PD Modification Application: PRS 22-0844
Zoning Hearing Master Date: N/A
BOCC Land Use Meeting Date: August 25, 2022

AGENCY REVIEW COMMENT SHEET

REVIEWER: James Ratliff, AICP, PTP, Principal Planner

8.2 Proposed Site Plan (Full)

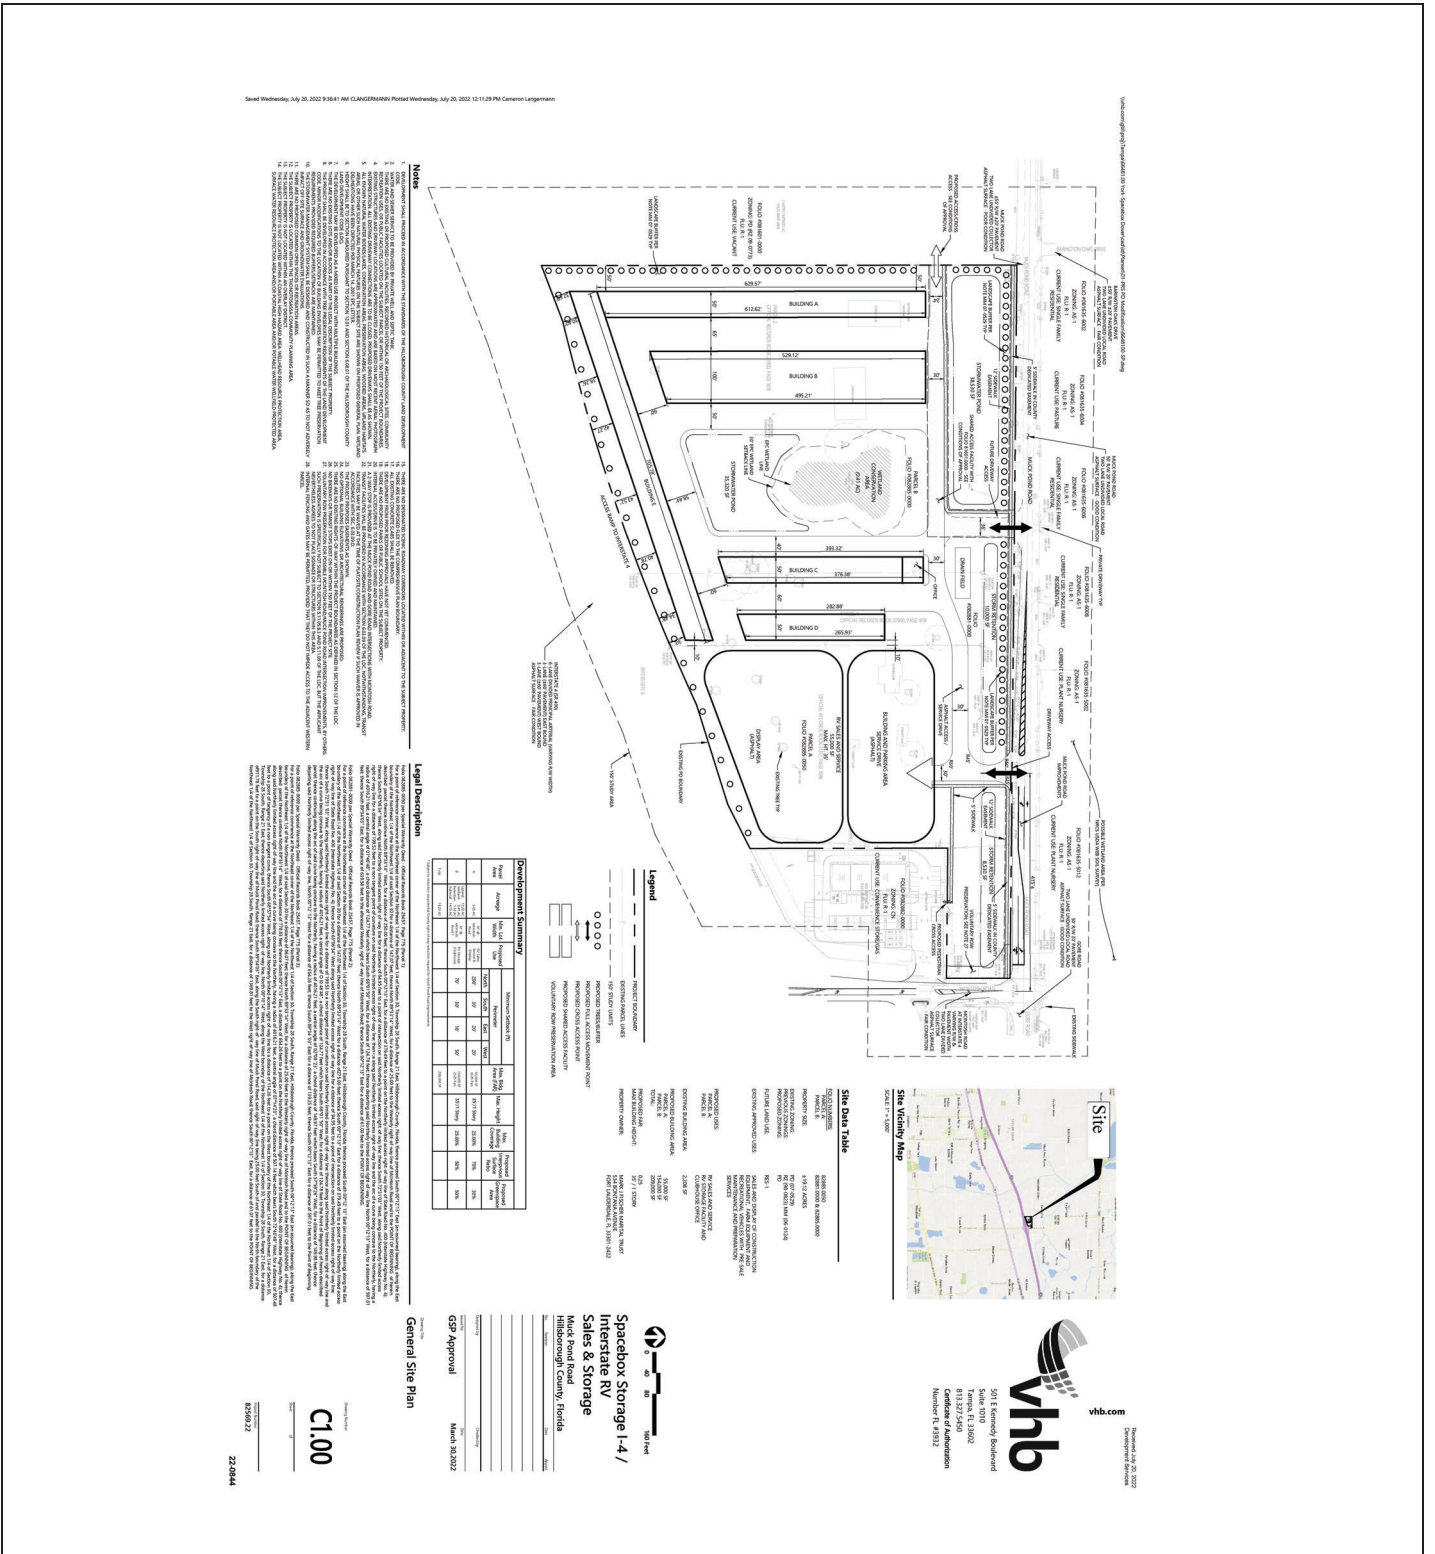
- Prior to PD site plan certification, the developer shall revise the PD site plan to:
 - Revise the labels reading "12' Sidewalk Easement" to state "15' Public Access, Utility and Maintenance Easement". Staff notes such revisions are necessary for consistency with the site plan shown in the requested Design Exception.

- Revise the labels reading "5' Sidewalk In County Dedicated Easement" to state "10' Multi-Purpose Path In County Dedicated Easement". Staff notes such revisions are necessary for consistency with the site plan shown in the requested Design Exception.

- Revise the label reading "Voluntary ROW Preservation; See Note 27" to read, "Voluntary Right-of-way Preservation – See PD Note 27 and Zoning Condition 26".

- Update the PD site plan for adjacent folio 82882.0000 to show the site improvements constructed within the adjacent project. Staff notes that the pedestrian infrastructure and cross access within that site are not as currently shown.

- Revise the location of the proposed pedestrian cross access and internal pedestrian infrastructure such that the sidewalk connection occurs along the adjacent folio's western project boundary, in the location such stubout was actually constructed (see below aerial).

- Revise Note 21 to change the words "is provided" to read "exists".
 - Revise Note 23 to add to the end of the sentence "and/or as required by the condition of approval."

- Replace Note 28 with a note reading something similar to "Internal fencing and gating may be provided. Reference zoning conditions, including conditions 12.6 and 25 for restrictions and other pertinent information."

FIGURE 2. PROPOSED TYPICAL 3 LANE SECTION

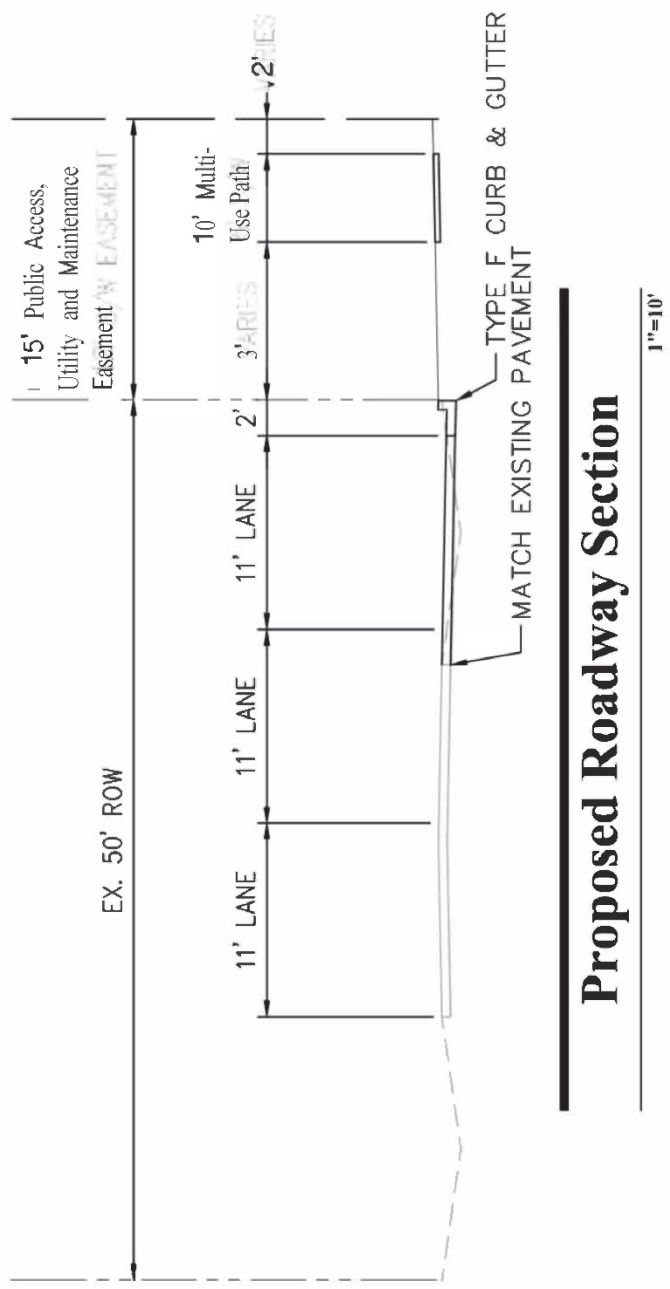
The County Engineer found the request approval with two conditions. First, the Design Exception showed a 10-foot wide multi-purpose pathway being provided along the entire project frontage, where as the text described it as only being provided between the easternmost driveway and McIntosh Rd. The County Engineer’s approval requires the improvements proposed in the attached site plan be constructed (i.e. the multi-purpose path along the entire project frontage). Second, the County Engineer noted that the latest revised request was sealed but was not signed. Provided the BOCC approves the zoning modification, the County Engineer required the applicant to submit a signed letter before they will formally approve the Design Exception.

I have found the attached Section Design Exception (DE) for PD 22-0844 APPROVABLE with Conditions. The Condition being that the 10' multiuse path be for the limits of the frontage as reflected in the drawing which is part of this request. Also, the applicant shall provide a signed copy of the DE should the Board approve the zoning.

3. An F type curb and 10-foot multi-use path will be provided only on the south side of Muck Pond Road from the beginning of the transition to the 3-lane section east to McIntosh Road. The multi-use path will be provided within a 15-foot public access, utility and maintenance easement. There is not enough ROW to provide a sidewalk on the north side of Muck Pond Road.

Pedestrian Sight Triangle Example:

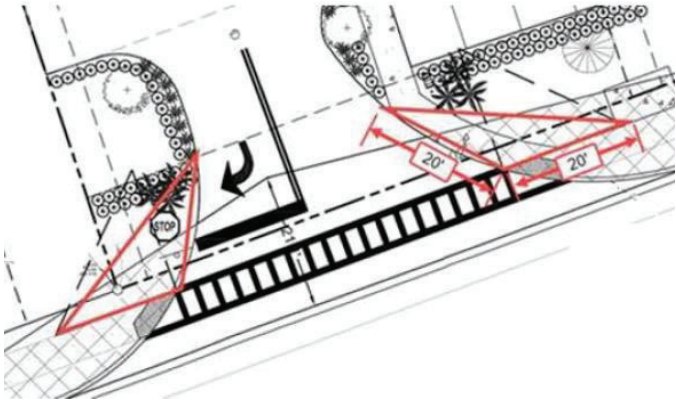
Driveways leading onto state roads need to have min. 20' x 20' clear 'pedestrian sight triangles' on each side of the driveway, at the edge of the sidewalk. It should be measured as 20' up the sidewalk and 20' up the driveway from the point at which the sidewalk meets the driveway. Nothing above 2' in height from the pavement elevation (except for the stop sign post) should be placed in these triangles. Also, no parking spaces should be in these triangles, not even partially. Please draw in and label these 'pedestrian sight triangles' on the plans. Here is an example of what these triangles look like and how they are positioned (see red triangles in the attached example)
